**CITY OF NORWALK  
REPORT TO THE NORWALK PLANNING COMMISSION**

**REQUEST:** Request from Locust Center, LTD to approve the Preliminary Plat of the *Twin Lakes Plat 4*

**MEETING DATE:** May 9, 2016

# TWIN LAKES PLAT 4 Preliminary Plat

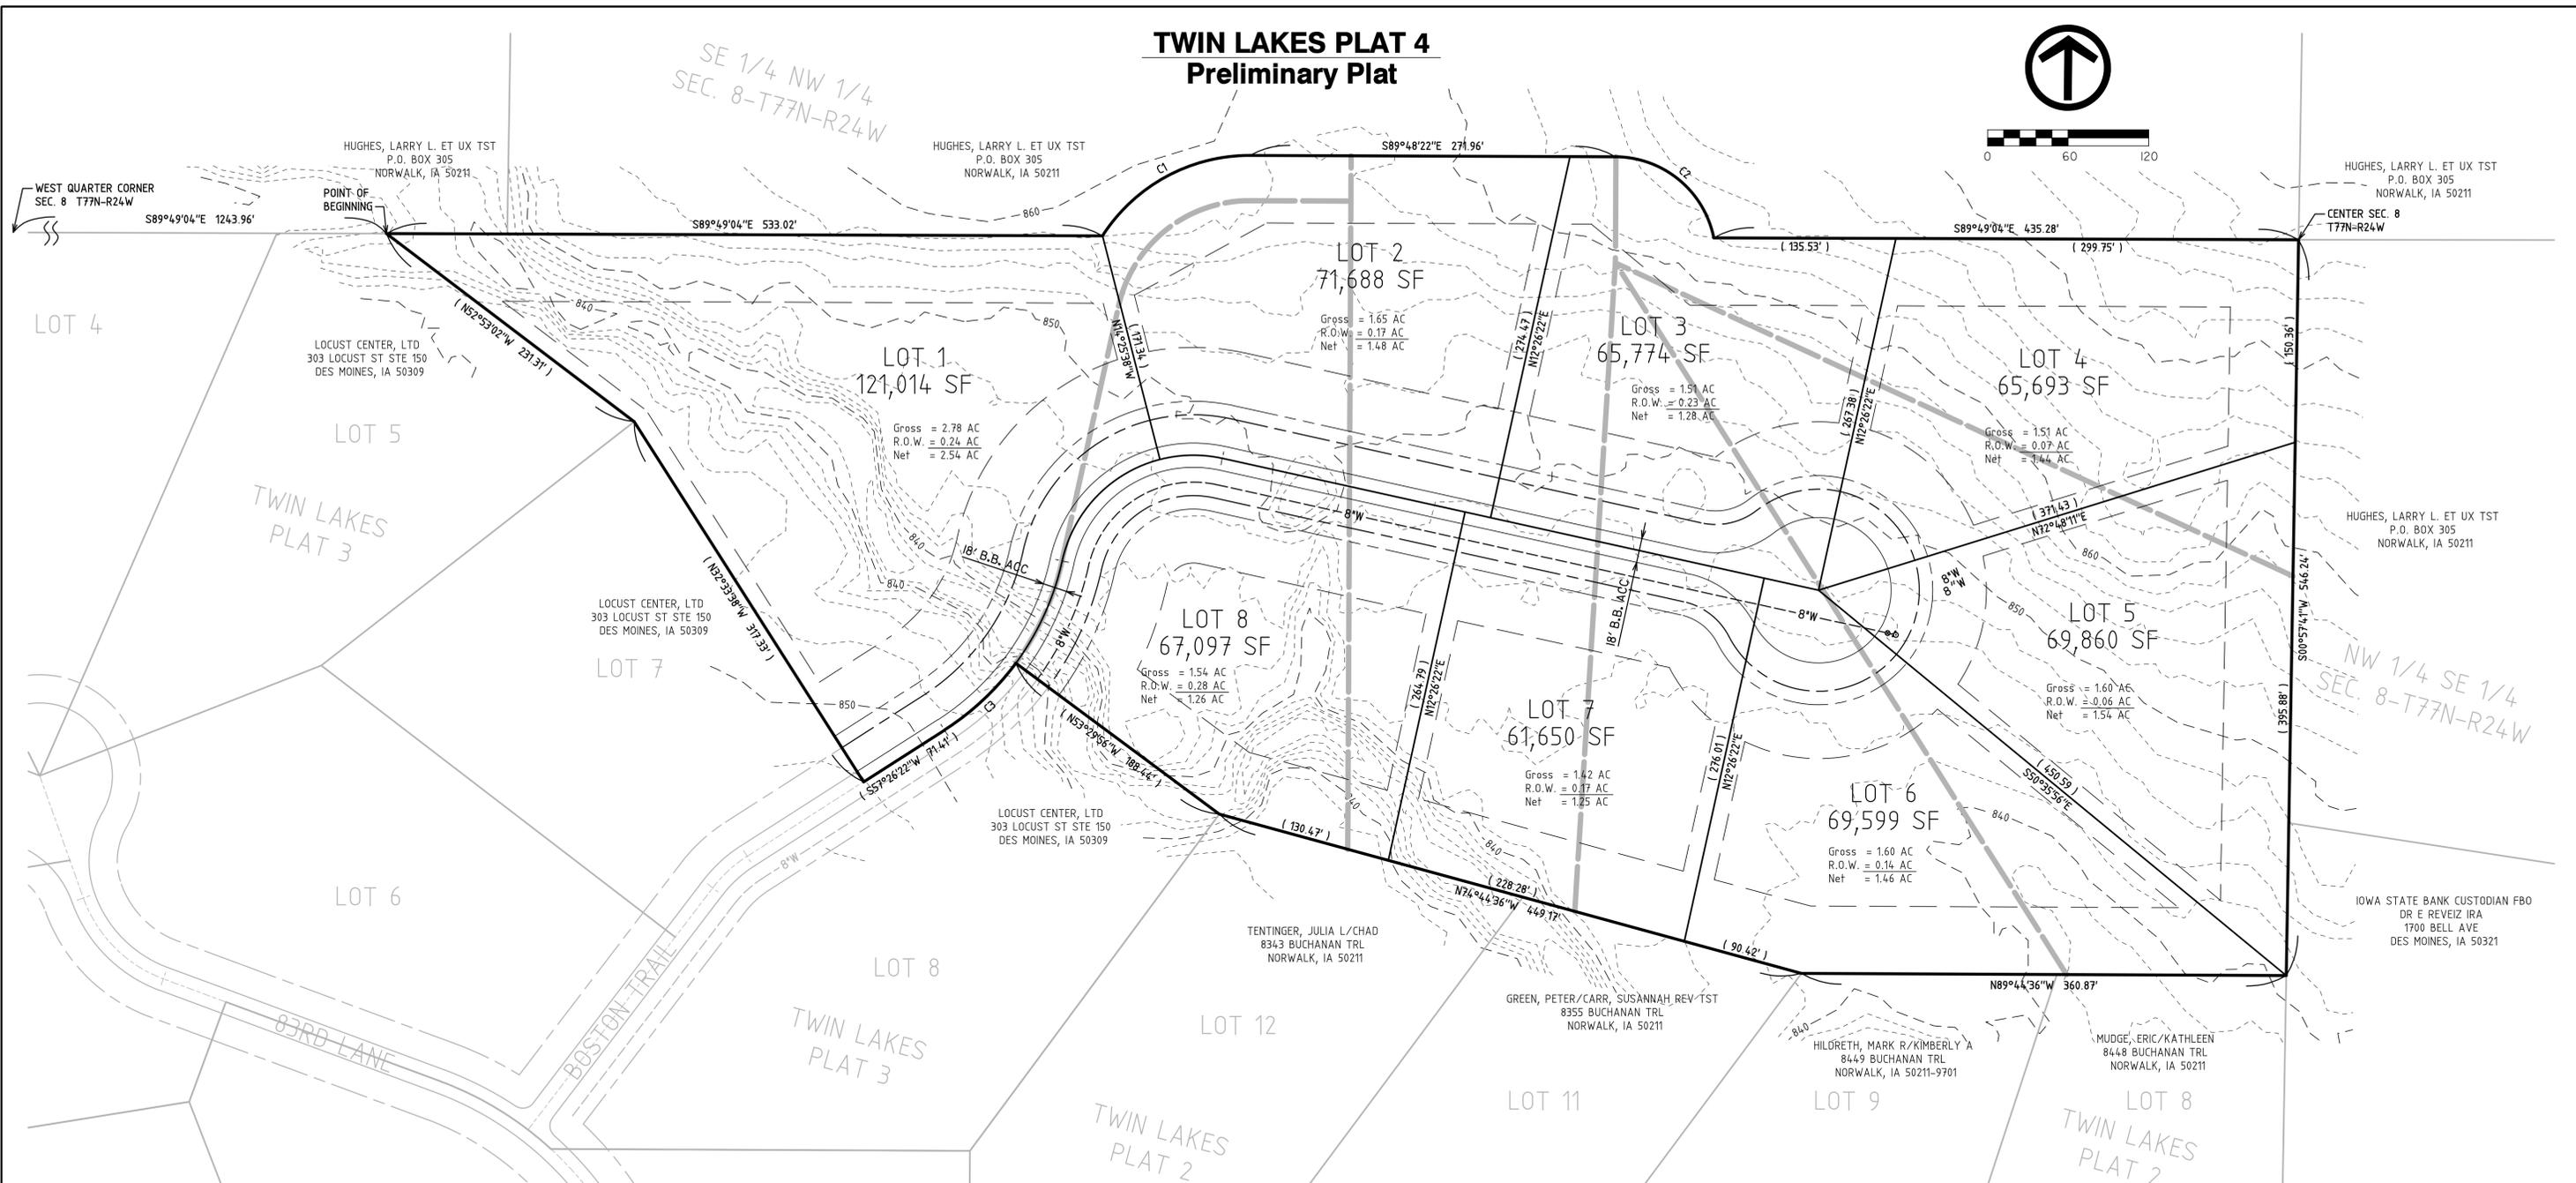
**VEHICULAR & PEDESTRIAN TRAFFIC:** The plat shows the extension of a private cul-de-sac, Boston Trail.

| <b>UTILITIES: WATER, SANITARY SEWER, STORM SEWER.</b> | <ul style="list-style-type: none"> <li>• An 8" water main is provided under Boston Trail.</li> <li>• Each lot will have their own septic tank for sanitary sewer usage.</li> <li>• One Hydrant is shown on Boston Trail at the end of the cul-de-sac, additional hydrants will be needed on lots as they develop to ensure adequate lot coverage.</li> </ul>   |

| <b>STAFF RECOMMENDATION:</b>                          | <p>Therefore, staff recommends that the request for the Preliminary Plat of Twin Lakes Plat 4 be approved for the following conditions:</p> <ul style="list-style-type: none"> <li>• That the applicant provides all supporting documentation required within the Norwalk Subdivision Regulations.</li> <li>• That any significant modifications to the final plat be reviewed and approved by the Planning &amp; Zoning Commission and City Council.</li> </ul> |
